CATHOLIC CENTRAL CONNECTOR ROAD JSP21-17

Public hearing at the request of Catholic Central High School for Planning Commission's approval of Preliminary Site Plan, Wetland Permit, Woodland Permit and Stormwater Management Plan. The subject property is zoned R-4 One Family Residential, R-1 One Family Residential, and I-1 Light Industrial and is located in Section 18, west of Wixom Road and south of Twelve Mile Road. The applicant is proposing to construct a new driveway to provide a connection from the existing loop road to Twelve Mile Road through the northern area of the property. Utilities, stormwater detention and wetland mitigation are also proposed.

PLAN REVIEW CENTER REPORT
Planning Review
CATHOLIC CENTRAL CONNECTOR ROAD
 JSP 21-17
 September 17, 2021

WETLAND AND BUFFER IMPACTS
 CATHOLIC CENTRAL HIGH SCHOOL CONNECTOR ROAD & UTILITY PLAN
 SECTION 18, CITY OF NOVI, MICHIGAN

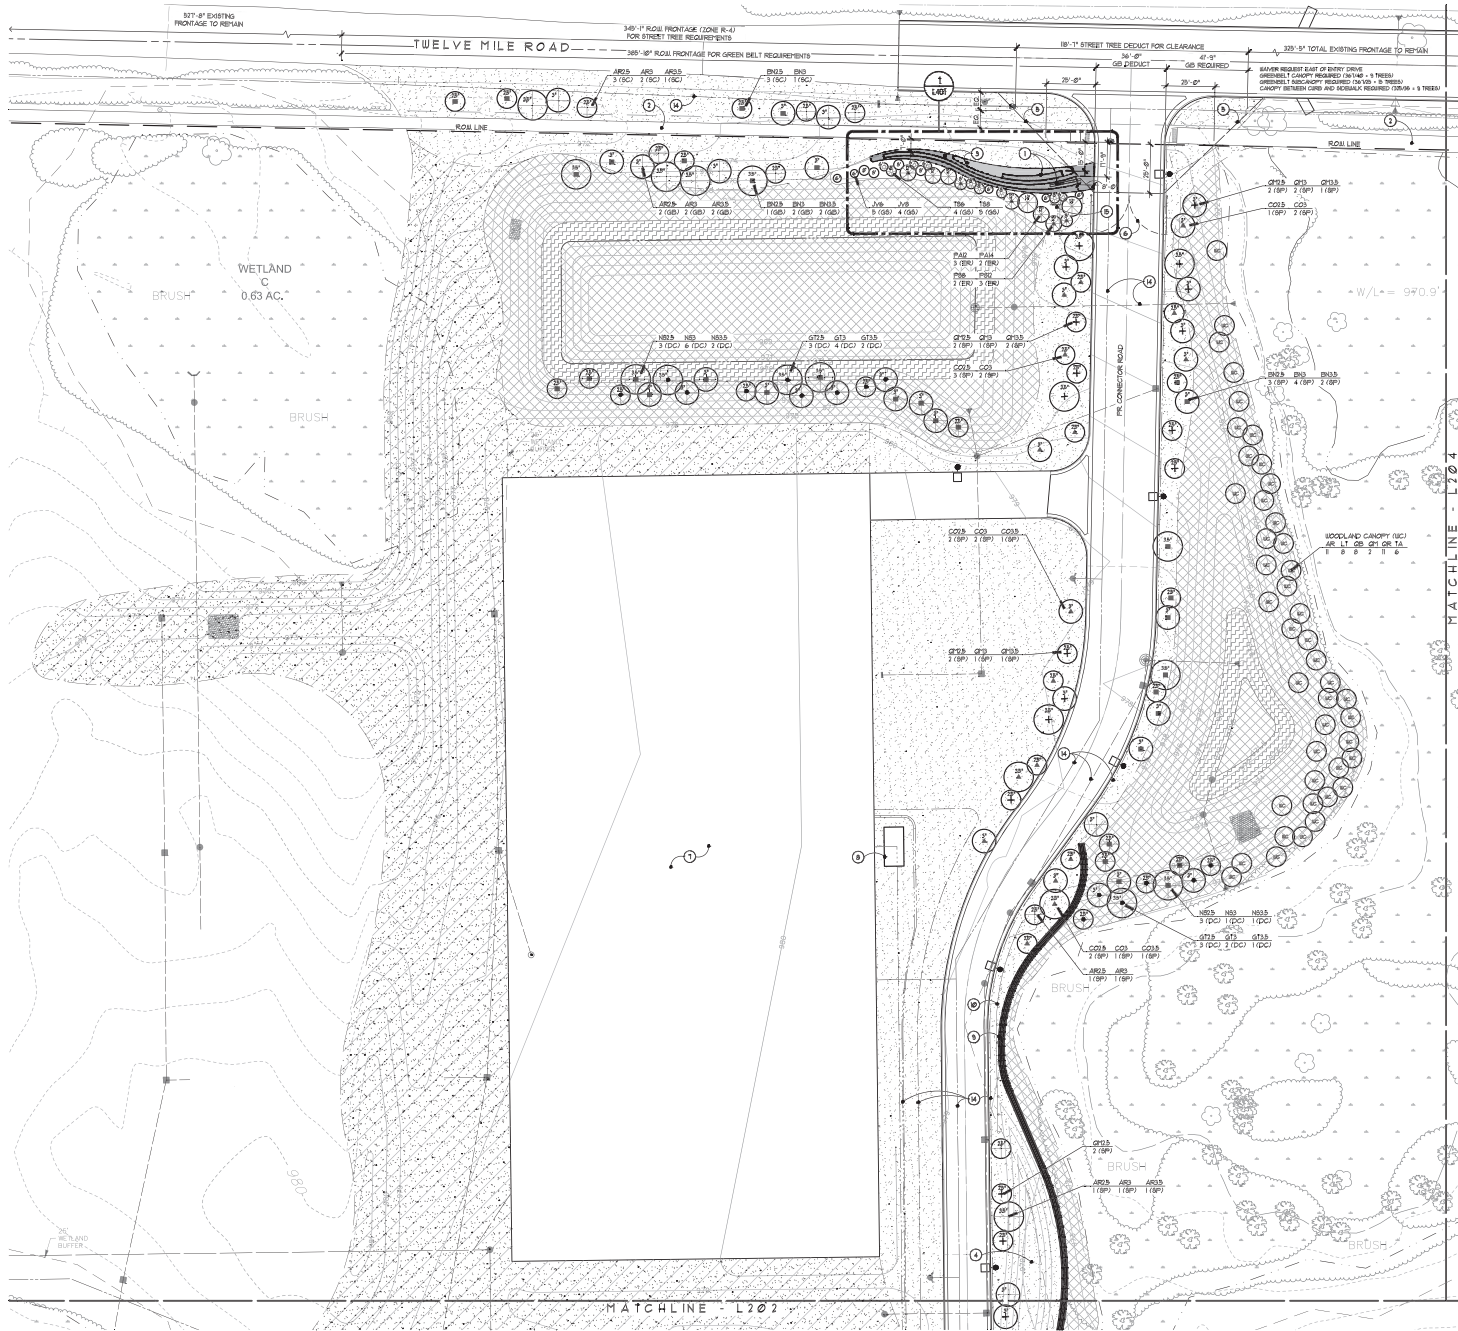
The Mannik & Smith Group, Inc. (MSG) completed a project site inspection relative to *Sheet CE-12, Wetland and Buffer Impacts of the Preliminary Site Plan and Stormwater Management Plan for Catholic Central High School Connector Road & Utility Plan* prepared by Zeimet Wozniak & Associates dated July 23, 2021, stamped Received by the City of Novi on July 27, 2021 (the PSP). The project site is located at 27225 Wixom Road, west of Wixom Road and south of Twelve Mile Road, Parcels 50-22-18-200-026 and 50-22-18-200-027, in Section 18 (Site). The PSP depicts construction of a paved connector road from Twelve Mile Road to the north to Catholic Central School Drive to the south and improvements to Twelve Mile Road. The PSP also depicts construction of three detention ponds and a wetland mitigation area. Sheet CE-12 of the PSP identifies anticipated areas of permanent wetland impact, permanent natural resources setback (buffer) impact, and temporary buffer impact.

MSG approximated the relative location of the proposed connector road on the City and EGLE maps, and compared the City wetland map to Sheet CE-12. It appears the areas shown as Wetlands A and E in the PSP approximately correspond to City-regulated wetland areas. Sheet CE-12 portrays impact to City-regulated Wetland E, the buffer of Wetland A, and impacts to wetlands and buffers that are not identified on the City of Novi Wetlands Maps. Sheet CE-12 also specifies 0.84 acre of wetland mitigation area is anticipated to be required.

Sheet CE-12 depicts construction of an on-Site 0.925-acre wetland mitigation area adjacent to Wetland E. Since the primary objective of the mitigation wetland is to replace forested wetland lost from Wetland E, the constructed wetland should be designed to result in forested wetland habitat.
